ADDENDUM NO. 1

Project: <u>2019 Water Well #23 Ground Storage Tank Replacement</u>		
Owner: <u>City of Kingsville</u>		
Engineer: <u>Rutilio P. Mora, Jr., P.E.</u>		
Addendum No. <u>1</u>	Specifications Section: <u>131000</u>	Issue Date: <u>05/17/19</u>
<p>Acknowledge receipt of this Addendum in the BID PROPOSAL submitted for this Project. Failure to acknowledge receipt of this Addendum in the BID PROPOSAL may render the BID as non-responsive and serve as the basis for rejecting the BID.</p> <p>Approved by: Rutilio P. Mora, Jr., P.E.</p> <div><div><u>Rutilio P. Mora Jr.</u> Name</div><div><u>5/17/2019</u> Date</div></div> <p>Addendum Items:</p> <ol style="list-style-type: none">1. Project Completion Time revised from 120 to 210 consecutive calendar days. Revised pertain to Bid Proposal, Standard form of Agreement between City and Contractor, and General Conditions (Item 39)-Contract Period.2. Revised Technical Specifications on section 131000 – Galvanized Steel Water Storage Tank – Wind Speed3. Revised Bid Proposal posted on May 17,2019.4. City will hire electrician to disconnect and connect level indicator to ground storage tank.5. Revised Storage Tank Detail A, Sheets 4. <div></

A ORIENTATION PLAN
2 SCALE: 1/8" = 1'-0"

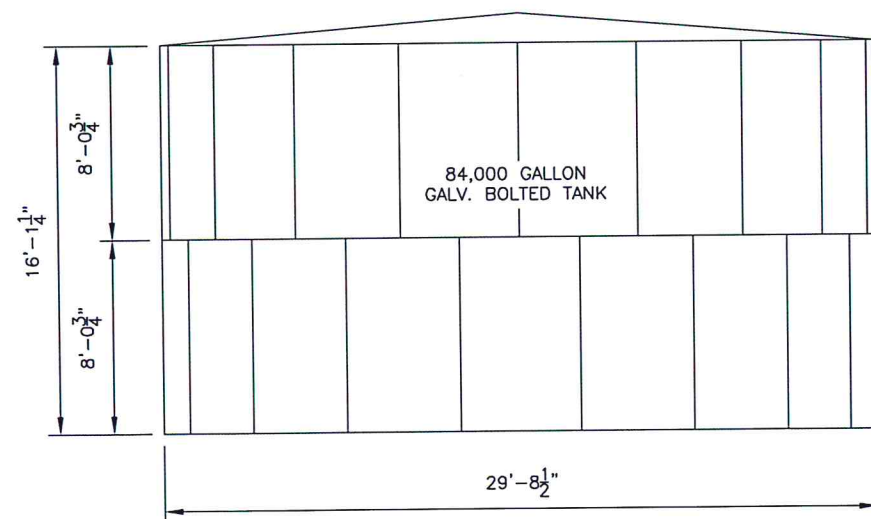
REVISED AS PER ADDENDUM No. 1
